ADDENDUM 02

Ridgewood Rehabilitation and Care Center

addendum no. 2

project name: Vetter Ridgewood Rehabilitation & Care Center

sketch **M1.0a**

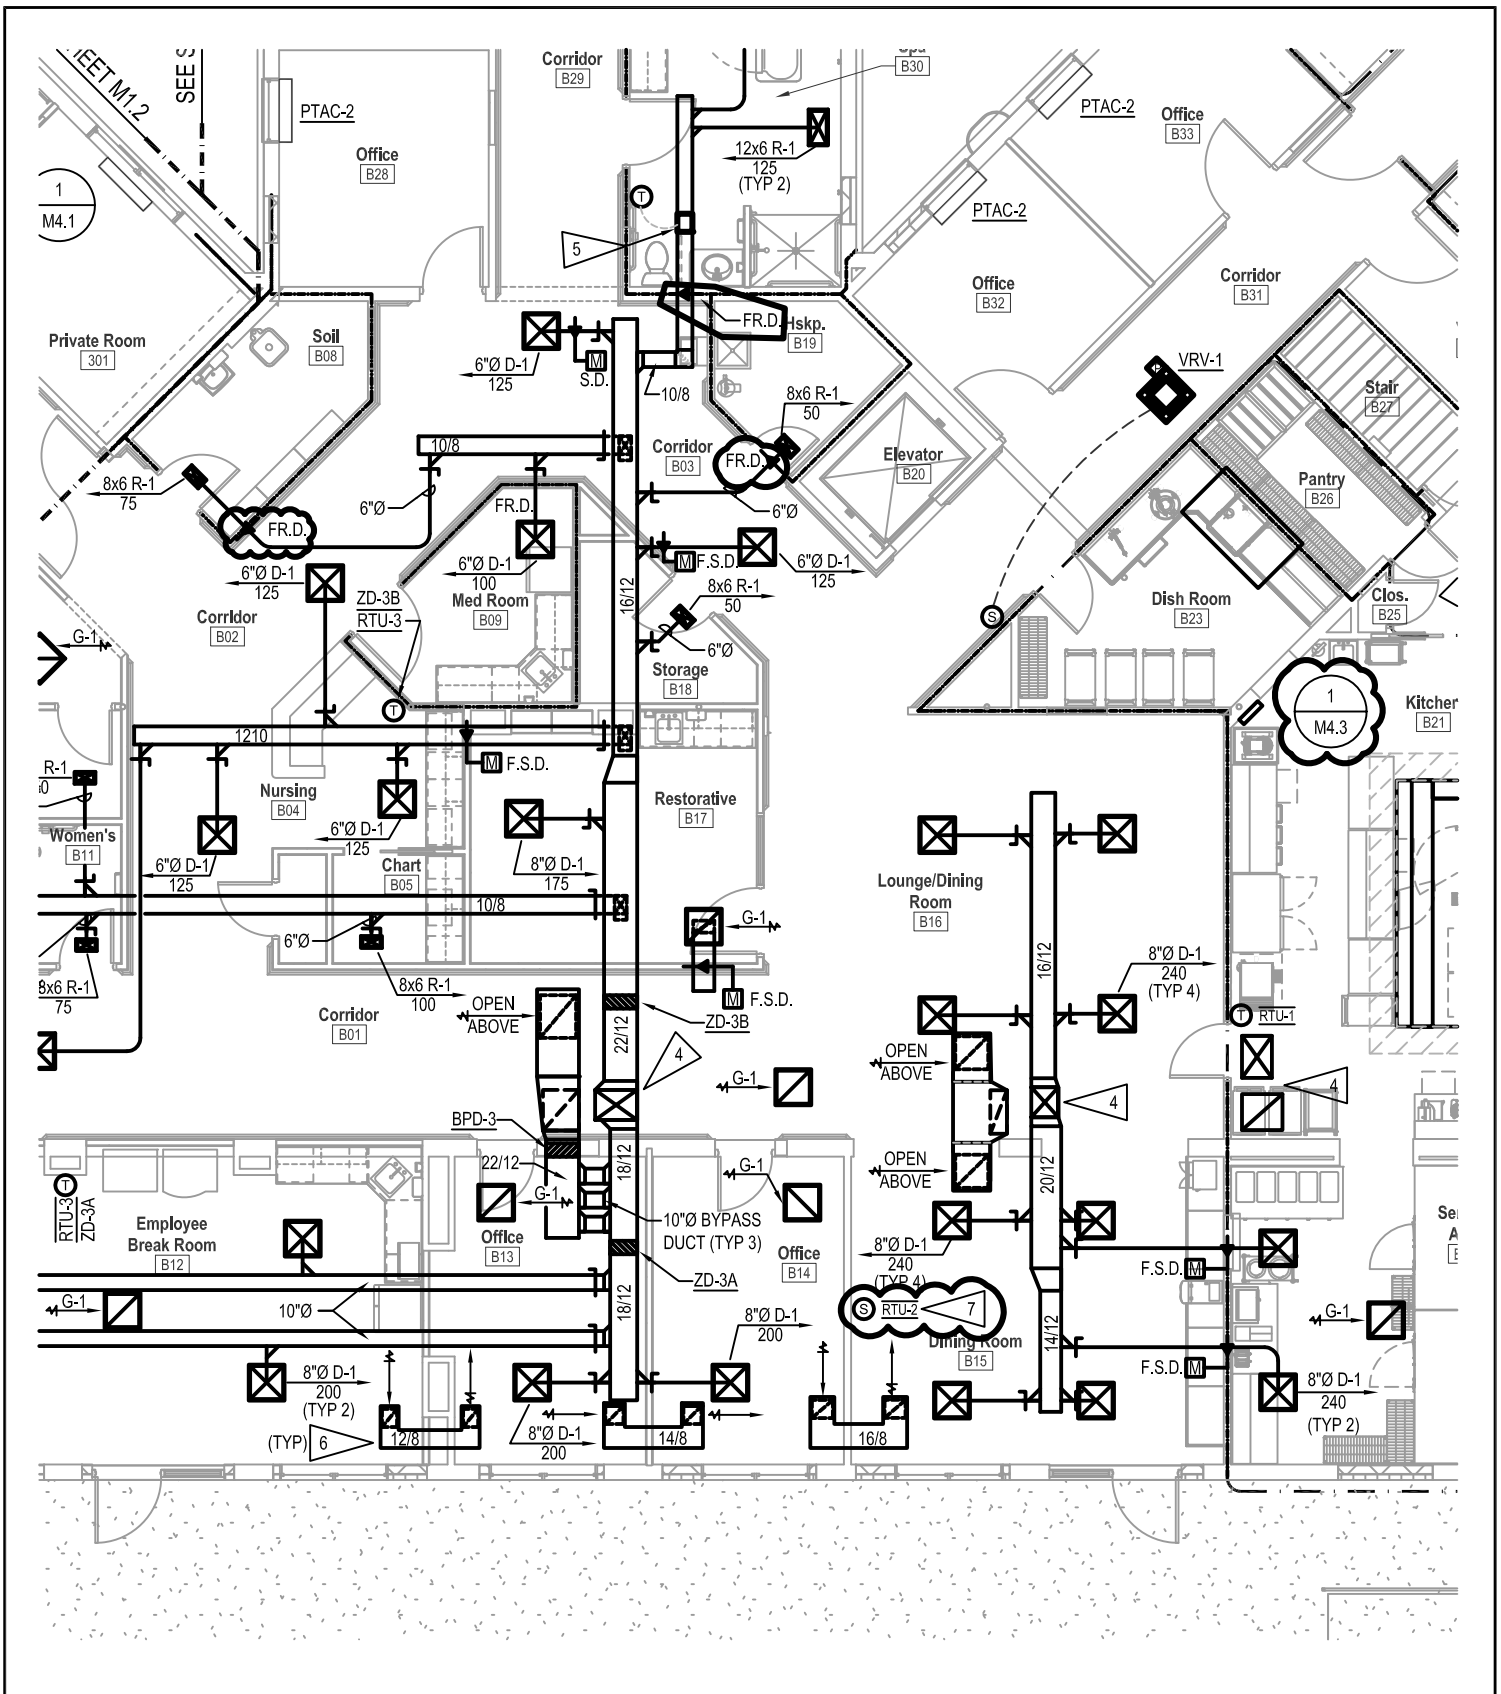
- a. Sheet M1.0 - East Building Basement - Heating and A/C Plan
 - i. See sketch sheet M1.0a
- b. Sheet M1.1 - East Building & Addition - Heating and A/C Plan
 - i. See sketch sheets M1.1a and b.
- c. Sheet M1.2 - West Building Addition - Heating and A/C Plan
 - i. See sketch sheets M1.2a and b.
- d. Sheet M2.0 - East Building Basement - Ventilation Plan
 - i. See sketch sheet M2.0a
- e. Sheet M2.1 - East Building & Addition - Ventilation Plan
 - i. See sketch sheets M2.1a and b
- f. Sheet M2.2 - West Building Addition - Ventilation Plan
 - i. See sketch sheets M2.2a and b

sketch **M3.1a**

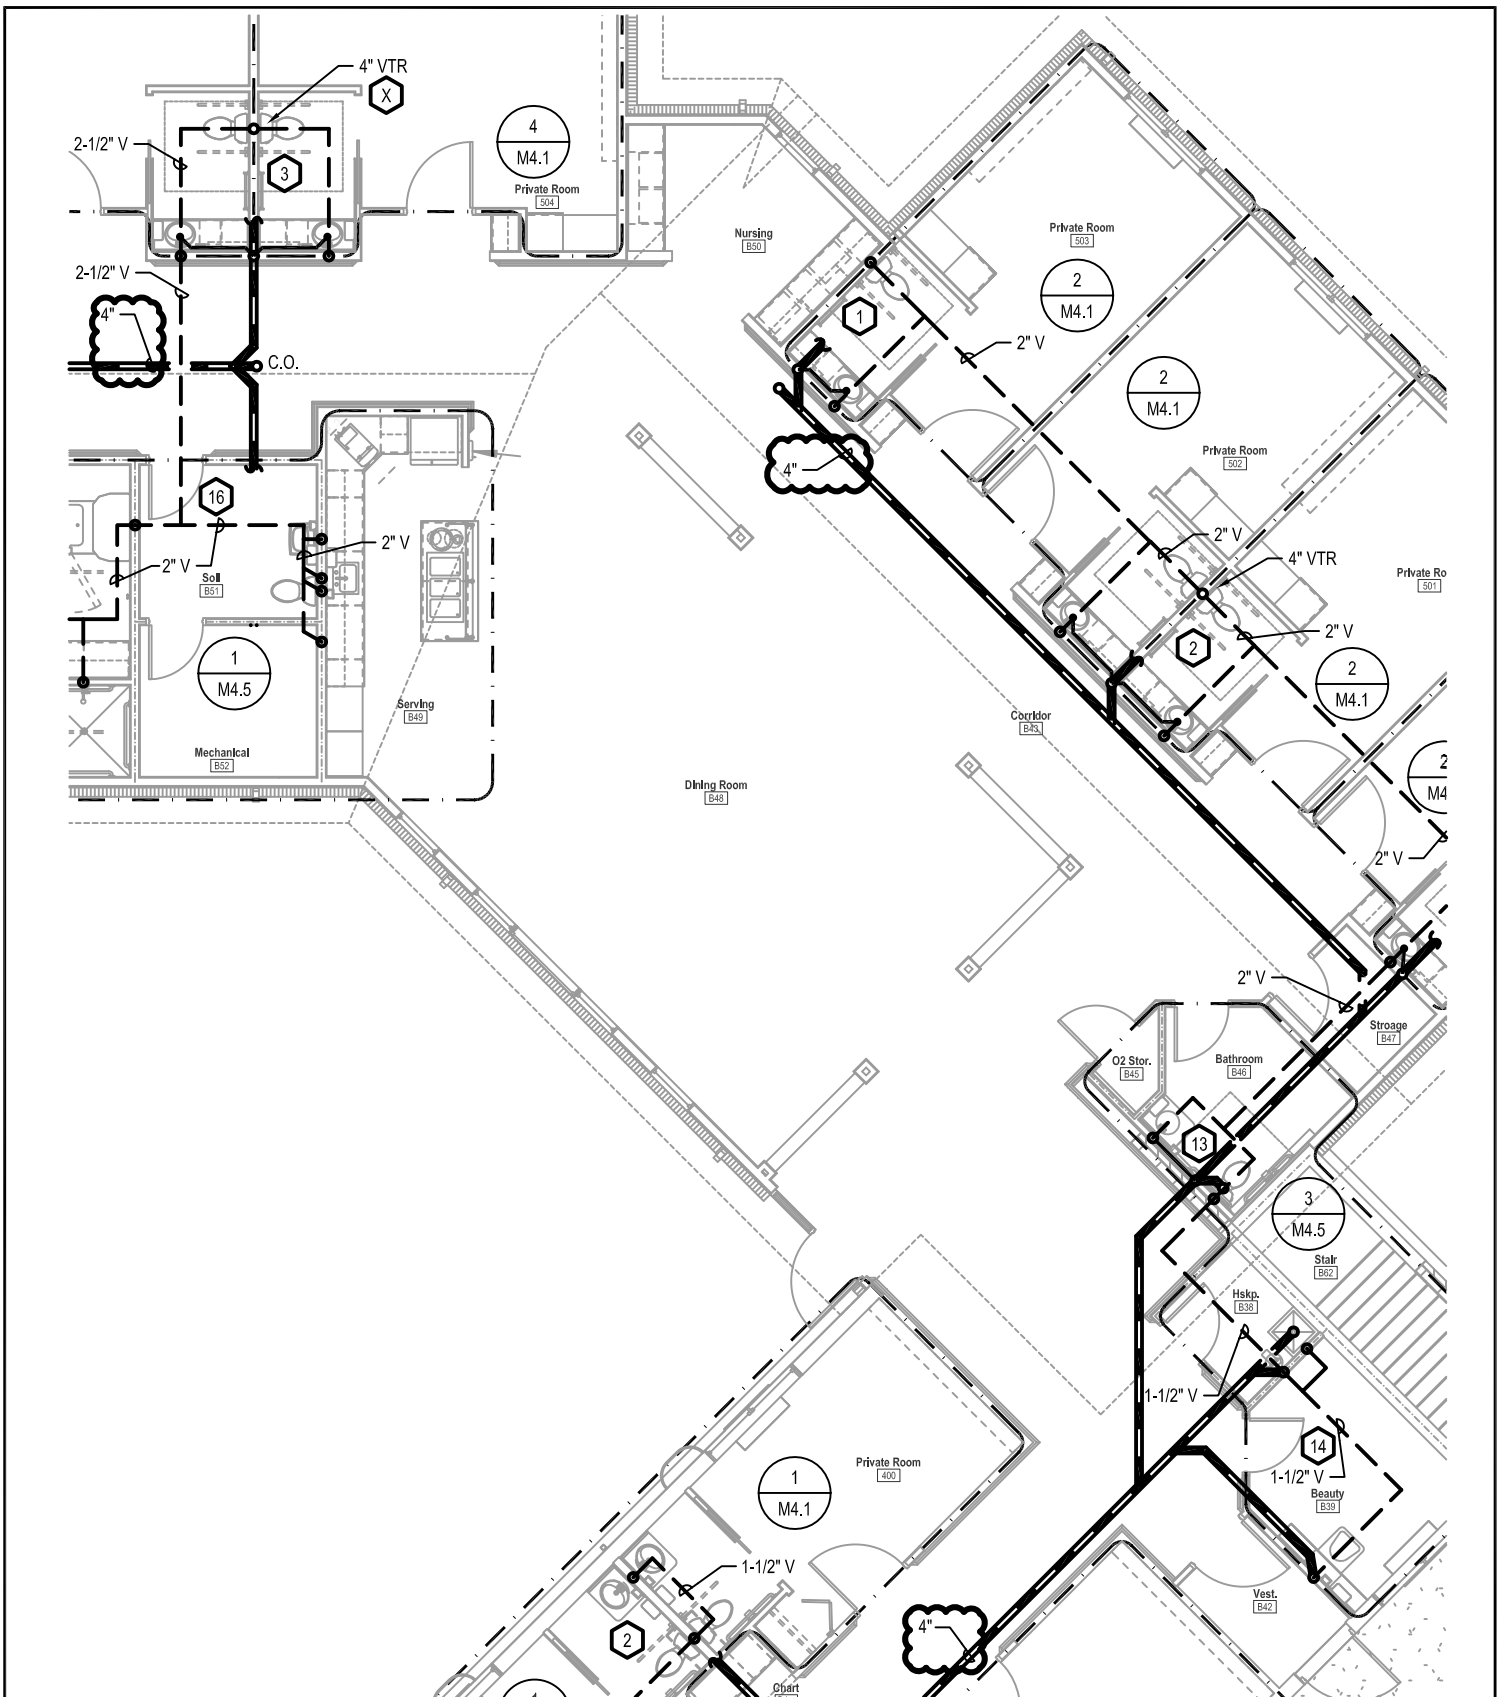
- g. Sheet M3.0 - East Building Basement - Sanitary Waste & Vent Plumbing Plan
 - i. See sketch sheet M3.0a
- h. Sheet M3.1 - East Building & Addition - Sanitary Waste & Vent Plumbing Plan
 - i. See sketch sheets M3.1a, b, and c
- i. Sheet M3.3 - East Building Basement - Water, Gas, & Fire Plumbing Plan
 - i. See sketch sheet M3.3a
- j. Sheet M6.2 - Mechanical Details
 - i. See sketch sheet M6.2a
- k. Sheet M7.2 - Mechanical Schedules
 - i. See sketch sheet M7.2a
